Committee of Experts on the Transport of Dangerous Goods and on the Globally Harmonized System of Classification and Labelling of Chemicals

Sub-Committee of Experts on the Transport of Dangerous Goods

Miscellaneous proposals of amendments to the Model Regulations on the Transport of Dangerous Goods

Comments on document ST/SG/AC.10/C.3/2010/43

1.

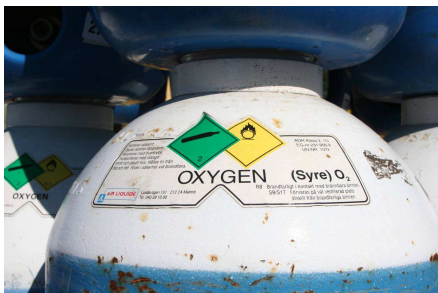
5. This document contains a number of pictures in colour taken of different pressure receptacles marked with labels, UN number and other information texts required, which show that particularly the size of the UN number on these receptacles is very small and hardly readable even from a close distance. The situation is similar for the reduced labels. To conclude, we believe that the UN number and the letters “UN” on these pressure receptacles without any difficulty can and should be at least 12 mm.

The marking of UN number (size 2,5 mm) and the letters “UN” on pressure receptacles with a water capacity of 14 litres (pictures 1 and 2).
